IMPORTANT SAFETY NOTICE

To: **All Users of Sperian Warrior Self-Contained Breathing Apparatus (SCBA)**

The purpose of this Important Safety Notice is to advise you of a potential safety issue with the Rapid Intervention Crew/Company Universal Air Connection (RIC UAC, hereafter referred to as the UAC) used in Sperian Warrior SCBAs.

Figure 1

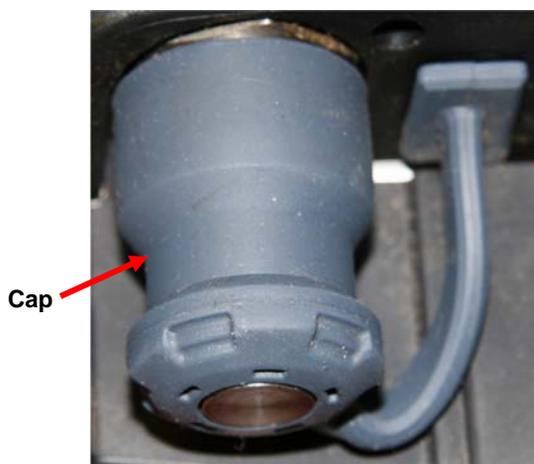
Under some conditions, it is possible to pull the protective dust cap off the pin in the pin-and-cap assembly, resulting in the pin remaining stuck in the UAC coupling. If the cap has separated from the assembly, the pin stuck in the coupling would prevent the coupling from functioning in a rapid intervention scenario.

This condition can occur when the pin has not been removed from the coupling for a long time. There is an internal o-ring in the coupling that seals against the pin. If the pin has not been "exercised" by removing it from the coupling periodically, it can take a set (become stuck) against the o-ring. The amount of force necessary to then remove the pin-and-cap assembly from the coupling may exceed the ability of the cap to remain attached to the pin, and the cap may separate from the pin.

1. Attempt to remove the pin-and-cap assembly from the UAC coupling (see Figures 1 and 2).

Figure 2

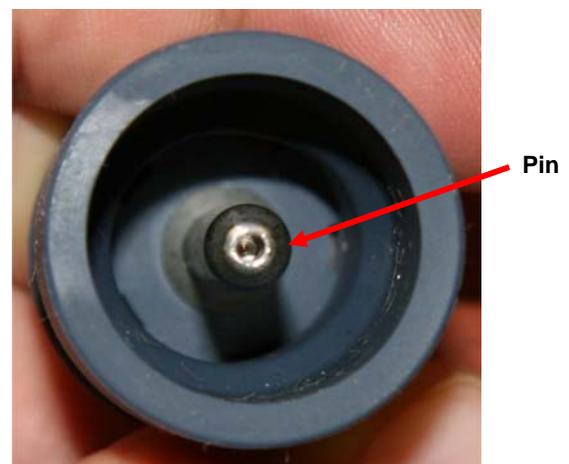
2. If the pin-and-cap assembly can be removed from the UAC coupling, inspect the pin to ensure that it is not bent (see Figure 2). If it is bent, contact your local Sperian Warranty Service Center to have a Sperian-certified technician replace the pin-and-cap assembly (Sperian part number 975641) on the Warrior; then follow the lubricating procedure in Step 3 below.
3. If the pin is not bent, use a cotton swab to apply a **thin** coat of Molykote 33 Light (Sperian part number 820489) to the sides of the pin shaft from just below the tip of the pin to approximately ¼-inch below the tip of the pin. Do not overlubricate. Do not apply Molykote 33 Light to the tip of the pin. Ensure that the cotton swab does not deposit any lint on the pin shaft. You do not need to be a Sperian-certified technician to apply Molykote 33 Light to the UAC pin.

4. Reinsert the pin into the UAC coupling. Test the pin by removing and reinstalling it at least three times. The pin should move freely into and out of the UAC coupling.

5. If, during the initial attempt to remove the pin-and-cap assembly from the UAC coupling, the cap separates from the pin and the pin becomes stuck in the UAC coupling, use pliers to remove the pin from the coupling, and contact your local Sperian Warranty Service Center to have a Sperian-certified technician replace the pin-and-cap assembly (Sperian part number 975641) on the Warrior. Apply Molykote 33 Light (Sperian part number 820489) to the new pin and test the pin as described above.

6. Relubricate the pin at least once a year with Molykote 33 Light during the annual flow test for the Warrior.
7. “Exercise” the pin monthly during your normal monthly checks by removing and reinstalling it at least once. The pin should move freely into and out of the UAC coupling.
